ADDENDUM NO. 1

September 14, 2026

**Perry Meridian High School Phase 2 Renovations
401 W. Meridian School Road
Indianapolis, IN 46217**

1 ELECTRICAL LIGHTING SECOND FLOOR PLAN - UNIT F
1/8" = 1'-0"

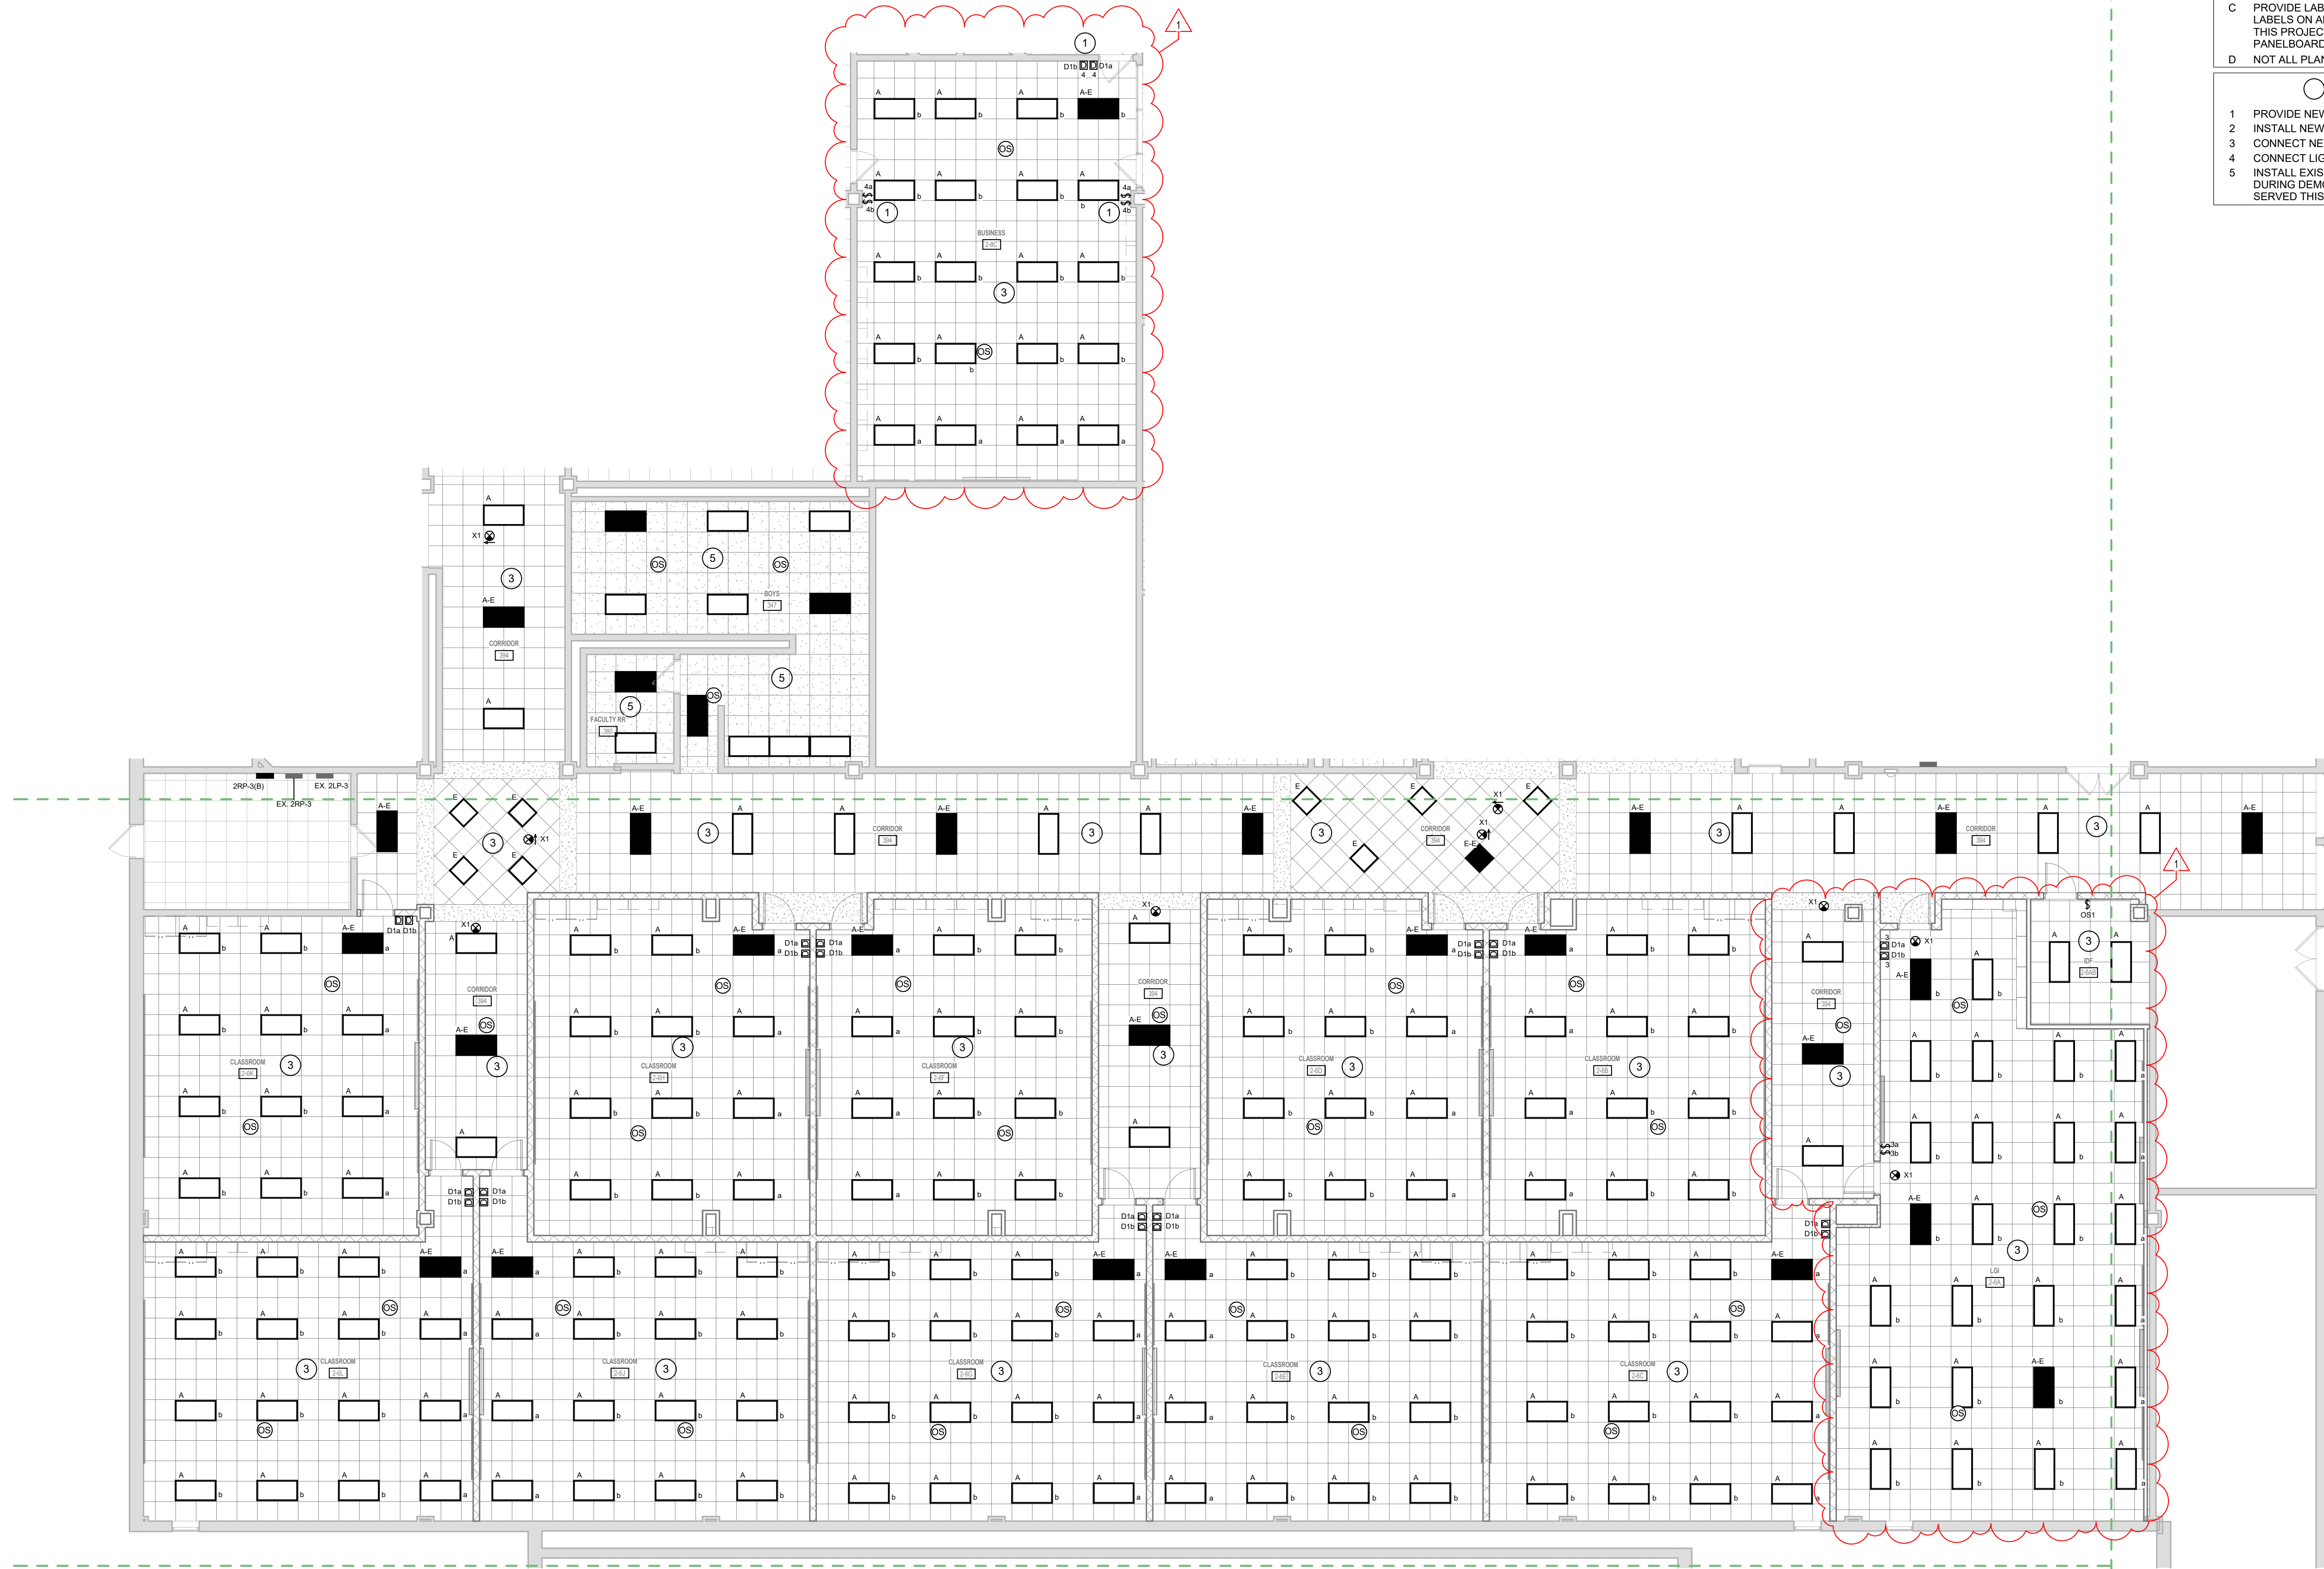
Change: Revise sheet to include scope of work to install new lighting and lighting controls in BUSINESS 2-8C.

- Revise sheet to change light fixture type to match ceiling condition in IDF 2-6AB.
- Revise sheet to change light fixture locations in CORRIDOR 394 and LGI 2-6A.
- Revise sheet to include scope of work to reinstall salvaged lighting and lighting controls in GIRLS 349 and FACULTY RR 350.

1. Revise sheet to include scope of work to install new lighting and lighting controls in BUSINESS 2-8C.

2. Revise sheet to change light fixture type to match ceiling condition in IDF 2-6AB.
3. Revise sheet to change light fixture locations in CORRIDOR 394 and LGI 2-6A.
4. Revise sheet to include scope of work to reinstall salvaged lighting and lighting controls in GIRLS 349 and FACULTY RR 350.

1 ELECTRICAL POWER & SYSTEMS SECOND FLOOR PLAN - UNIT F
1/8" = 1'-0"

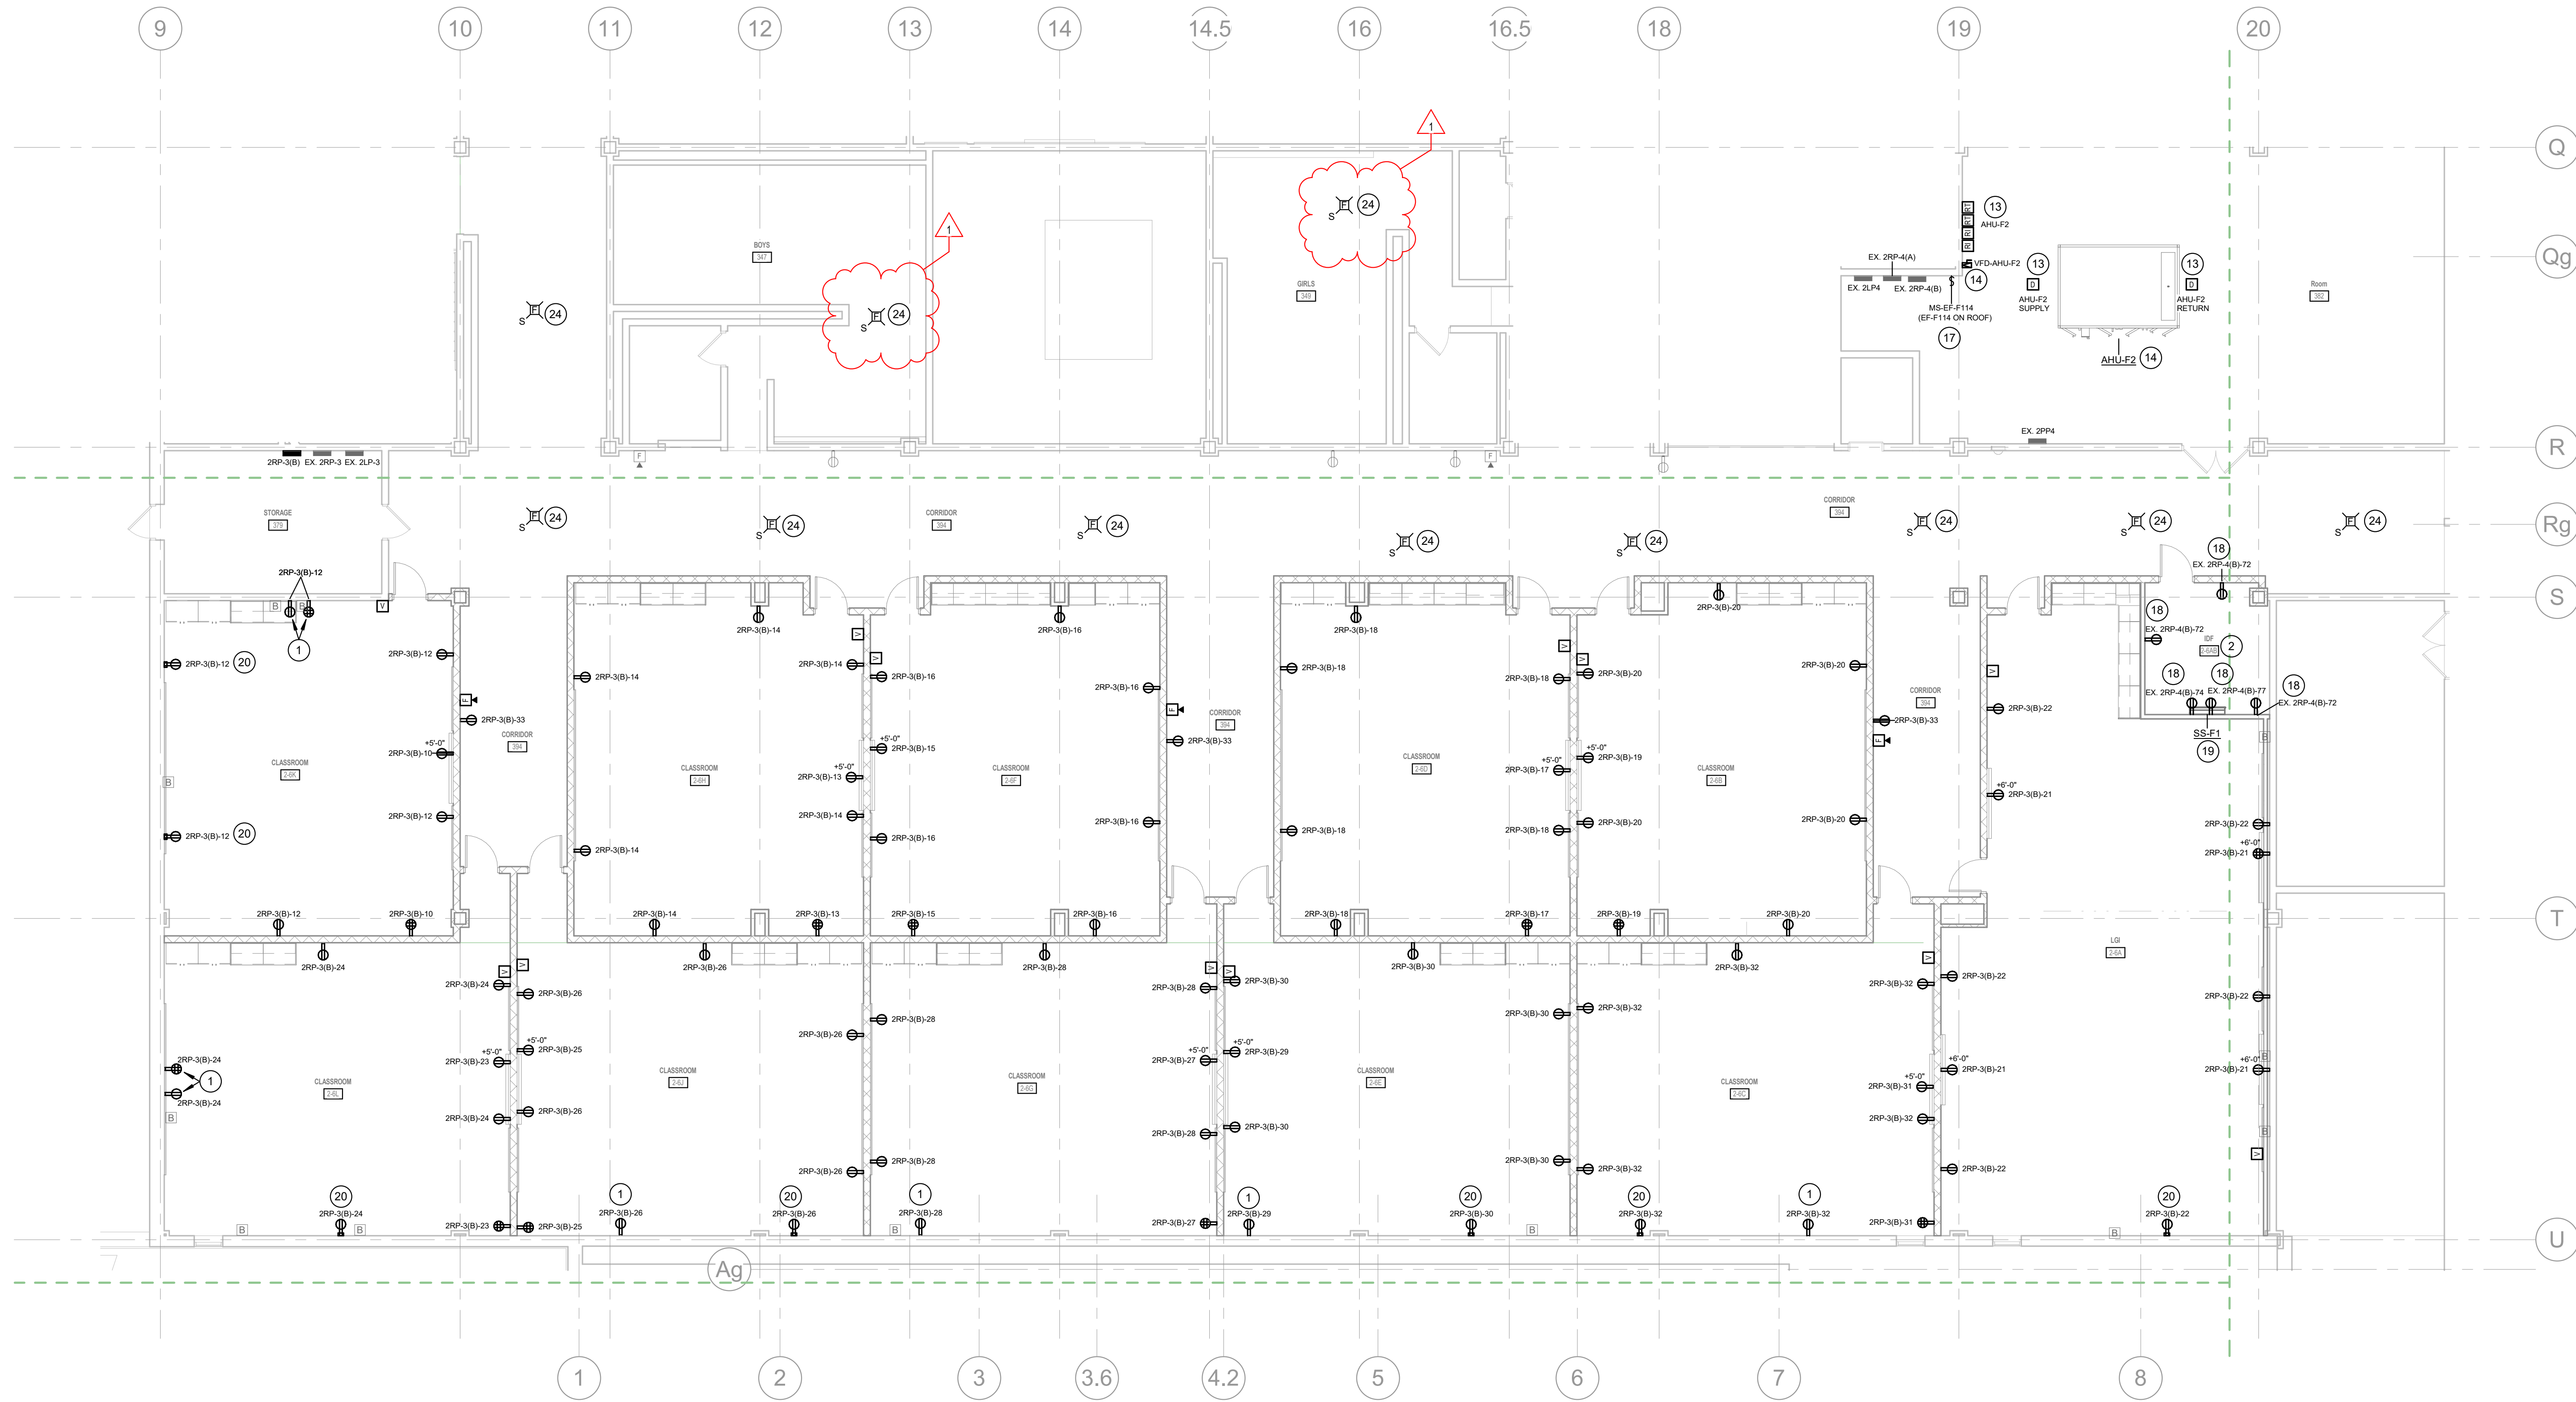
Change: Revise sheet to reinstall salvaged fire alarm smoke detectors in BOYS 347 and GIRLS 349.

1. Revise sheet to reinstall salvaged fire alarm smoke detectors in BOYS 347 and GIRLS 349.
